Access Compliance Report

Public Rights-of-Way

(Curb Ramps)

Intersection ID: 44823	Main Street: SPRING_OAK_DR	Cross Street: GOLDEN_RIDGE_LN	Location: SE
ADA ID: A8A13A4BC5DF	Ramp Type: PerpDiag	Initial Pass/Fail: Fail	Overall Compliance: No
Severity Score: 10			
Codes/Mitigation Info/Possible Solution		Field Measurements/Component Compliance

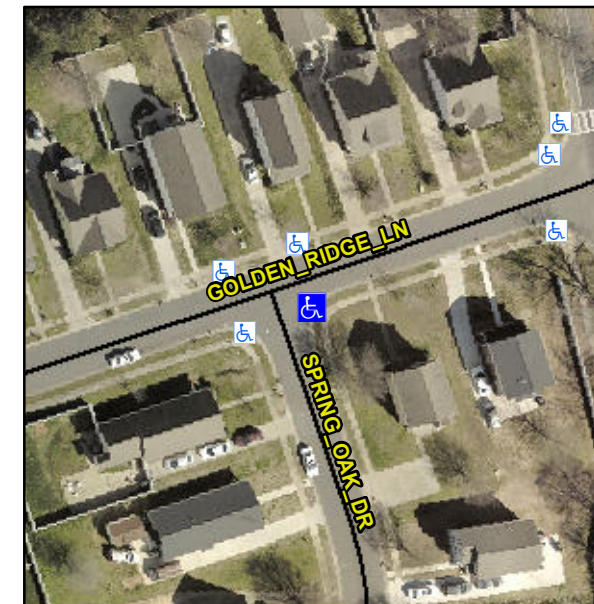
Compliance	Description	Data	Compliance	Description	Data
N/A	Ramp Length (in)	48.0	Yes	Ramp Slope (%)	5.2
No	Ramp Width (in)	40.0	No	Ramp XSlope (%)	2.3
N/A	Flare Type LT	N/A	N/A	Flare Type RT	N/A
N/A	Flare Slope LT (%)	N/A	N/A	Flare Slope RT (%)	N/A
N/A	Flare Traversable LT?	N/A	N/A	Flare Traversable RT?	N/A
N/A	Landing Length (in)	N/A	N/A	DWS Provided?	N/A
N/A	Landing Width (in)	N/A	N/A	DWS Contrast?	N/A
N/A	Landing Slope (%)	N/A	N/A	DWS Length (in)	N/A
N/A	Landing X Slope (%)	N/A	N/A	DWS Full Width?	N/A
N/A	Landing Curb? (Y/N)	N/A	N/A	DWS Offset (in)	N/A
N/A	Shared Landing?	N/A			
N/A	Gutter Ponding?	N/A	N/A	Gutter Slope (%)	N/A
N/A	Gutter Lip Ht (in)	N/A	N/A	Gutter X Slope (%)	N/A
N/A	Painted X Walk1?	No	N/A	Painted X Walk2?	No
	X Walk 1 Direction	To N		X Walk 2 Direction	To W
N/A	X Walk 1 Width (in)	N/A	N/A	X Walk 2 Width (in)	N/A
	X Walk 1 Slope (%)	3.5		X Walk 2 Slope (%)	3.8
	X Walk 1 X Slope (%)	3.6		X Walk 2 X Slope (%)	6.0

N/A	Ramp inside XWalk1?	N/A	N/A	Ramp inside XWalk2?	N/A
	Road Slope (%)	0.6	N/A	Clear Space?	N/A
	Road X Slope (%)	3.8	N/A	Clear Space to XWalk (in)	N/A
N/A	Any Obstructions?	N/A	N/A	Storm Grate/Utility Hazard?	N/A
	Obstruction Type			Storm Grate/Utility Type	
		N/A			N/A
			Yes	Surface Condition? (G/P)	Good

Remove & Replace Curb Ramp With Two New Directional Ramps or Equivalent.

R304.5.1, R304.5.3
